LIVSEY & COMPANY, INC.	
DONALD C. COOK NUCLEAR PLANT	
DWN: WLP	DATE: 9/11/71
CKD: GN	DATE: 9/29/71
ISSUED	DWG. NO.
REF. DWG. 1-5497	1-NSW-42
	SHT 2 OF 2

1NSW-42 (sheet 2 of 2)
Upper Containment Ventilation
Unit 3 Supply Line

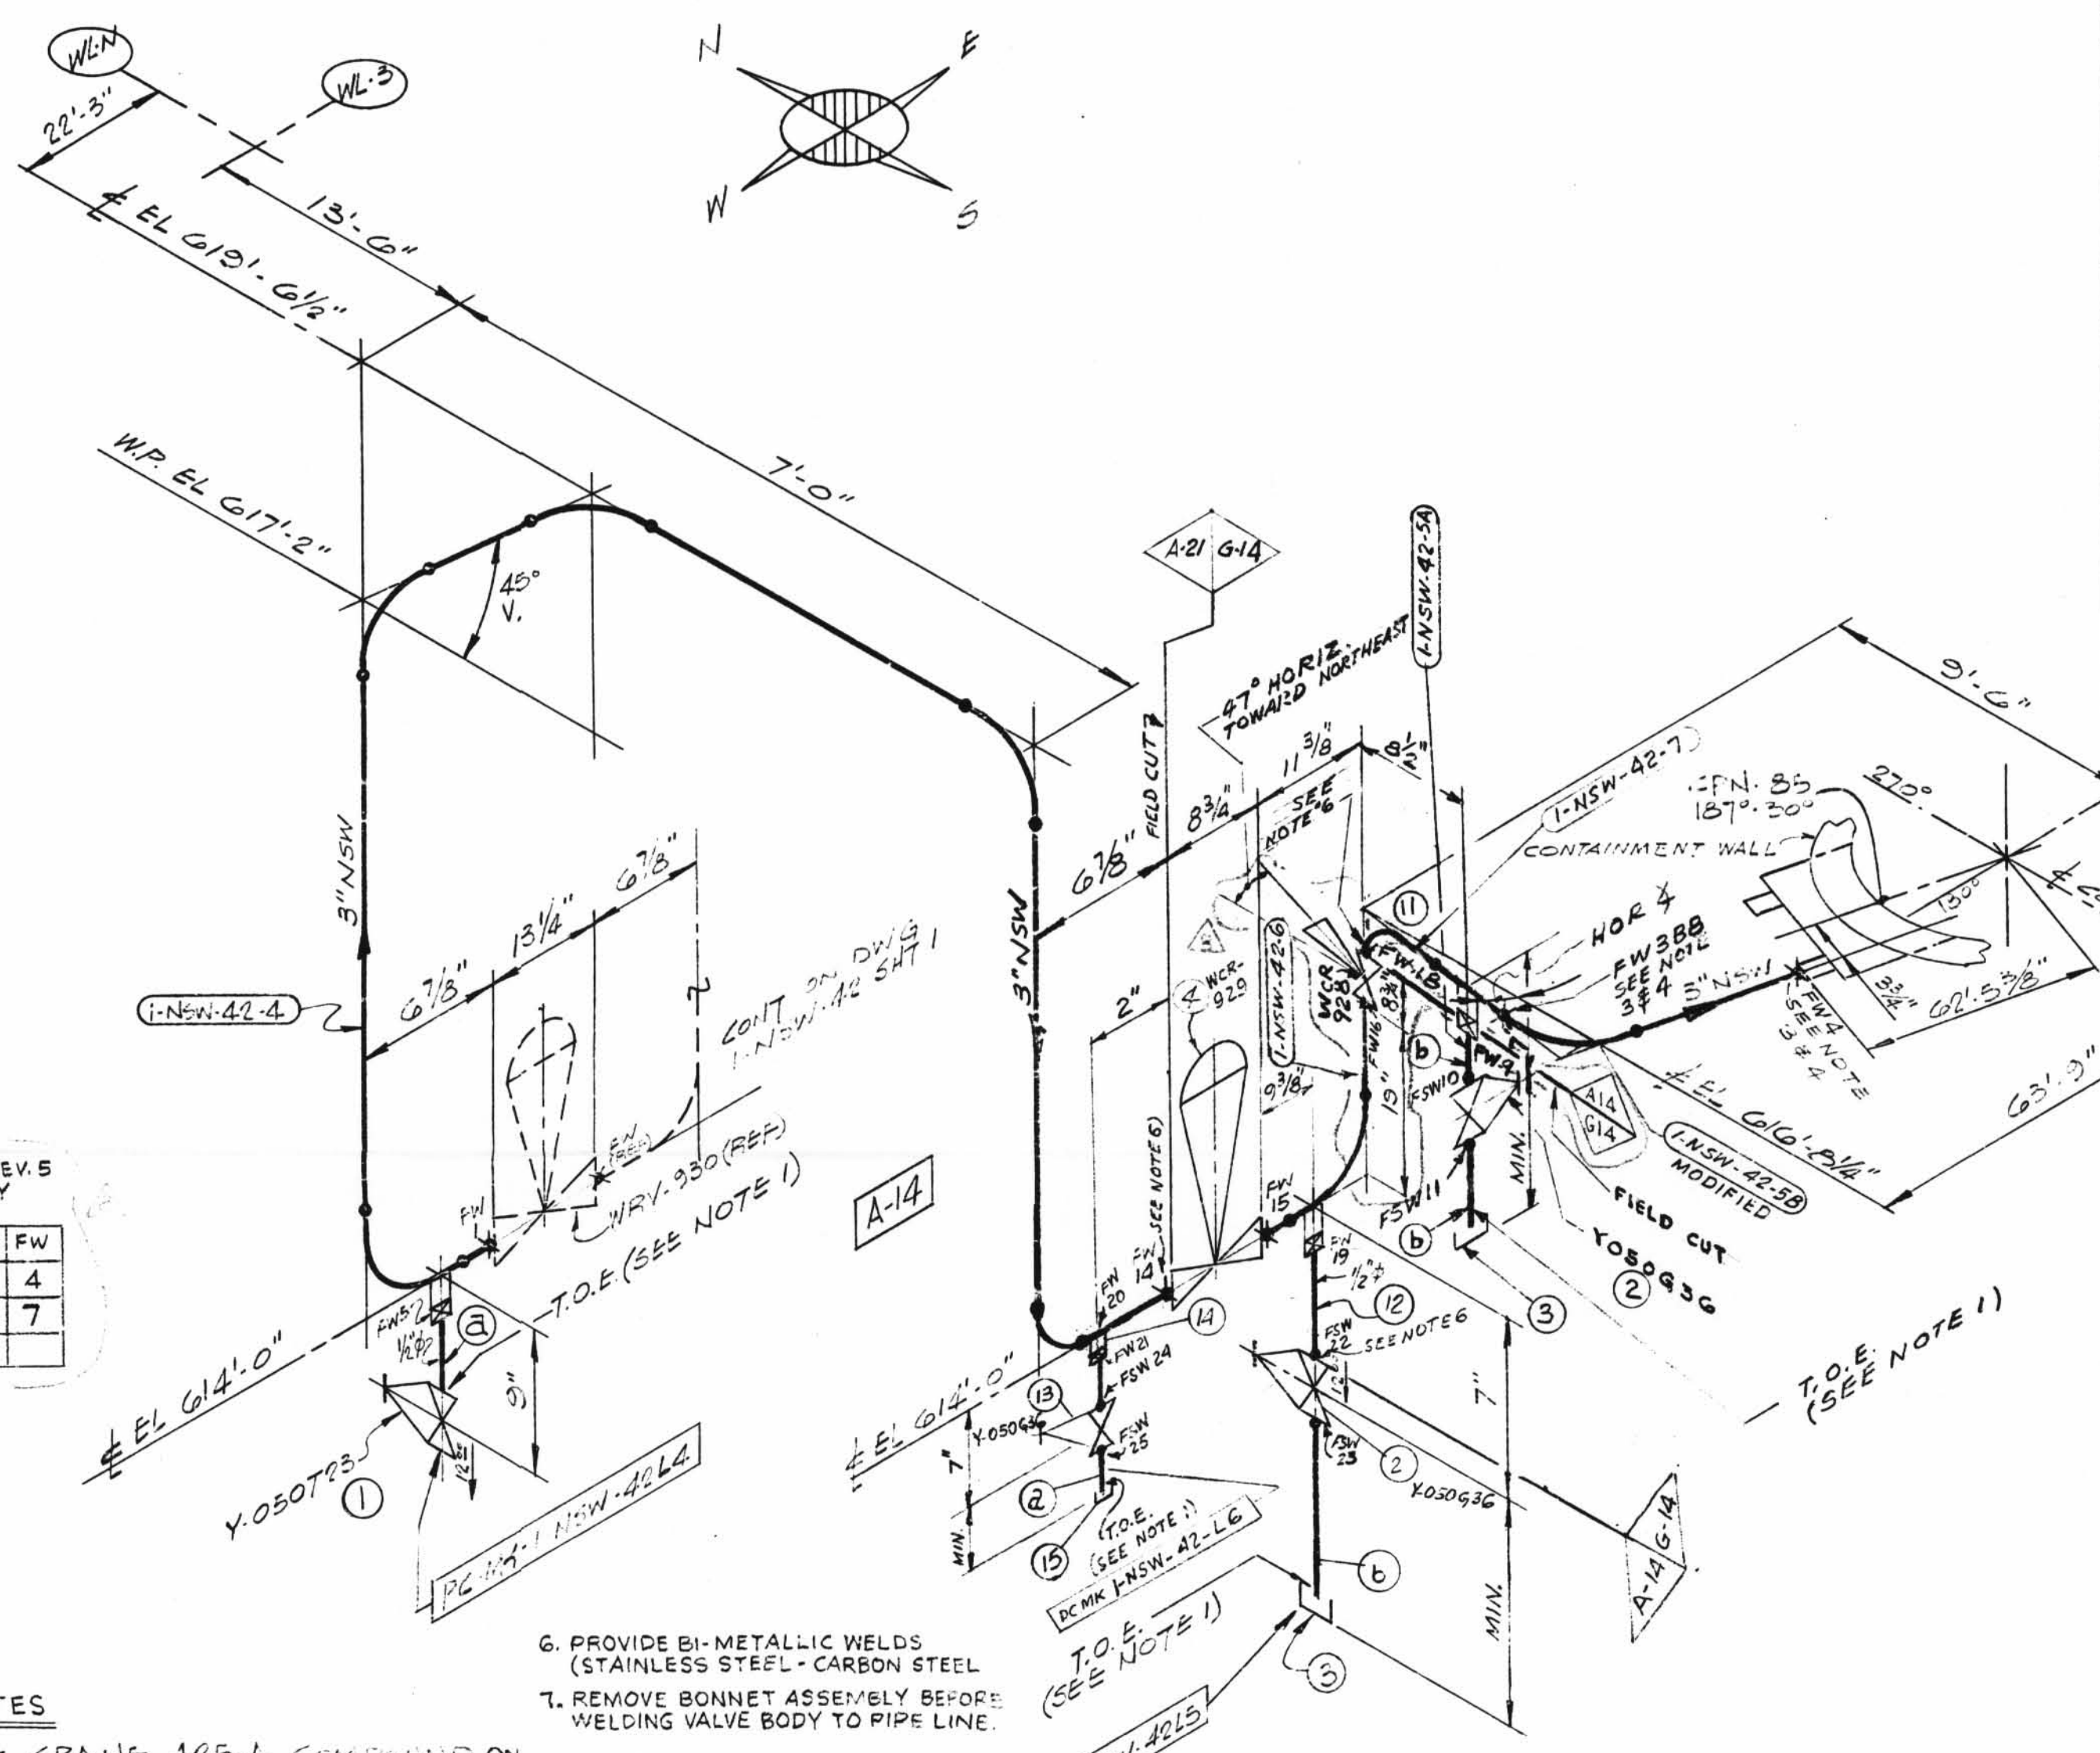
REV.	DATE	DR	CHK	DESCRIPTION	REMARKS
1	5/8/82	S.G.	GN	RELEASED: PIPING AT CPN. ADDED: FW, PC MK 5A & 5B; NOTES 3, 4 & 5, PO. # BOX FOR TOTAL NO. OF FWS; ITEM 4 REVISED: QTY FOR ITEM 2; NOTE 2; LOCATION OF SPEC CHANGE, DELETED: VALVE, FSW 8 & 10 PER DWG. 1-5497-3 & 1-5497A-3	FIELD ACTION REQD FAB. ACTION REQD
2	7/14/75	R.A.	A	REV'D; ITEM #2 Y050636 WAS CY050636 - REVISED BY A.E.P.	NO ACTION REQD
3	1-20-76	N.M.		REVISED BY A.E.P. DESIGN PER REC DC-12-2549 TO REFLECT AS BUILT WHEN CHECK VALVE WAS ADDED.	
4	2/1/78	H.B.	LB	PER REC #12-1430 DELETE ITEM 5 & ADDED ITEM 6, 7, 8, 9, 10 SEE DETAIL 'A'	FIELD ACTION REQD
5	1/13/82	J.L.	DK	PER REC DC-12-2549. ADDED: PIPE SPEC. G-10, DIM'S, PC. MKS. G & 7, LG FIELD WELD BOX, NOTES 6 & 7, FW 14 THRU 21, FSW 22 & 25, ITEM NO'S 11 TO 15 TO B/M. DELETED ITEM NO'S 6 THRU 10 FROM B/M. REVISED ITEM NO. 8 IN B/M. MODIFIED PC. MK'S 5B & 6 & 7.	FIELD ACTION REQD
6	1/2/82	J.M.	LG	PER REC DC-12-2549 RELOCATED FIELD CUP 15 PER FIELD CUP 15	FIELD ACTION REQD

NO.	DATE	DESCRIPTION
7	7/1/82	PER REC DC-12-2549, J.M. RELOCATED FIELD CUP 15 PER FIELD CUP 15
8	7/1/82	PER REC DC-12-2549, J.M. WAS 10% & DELETED FW 10
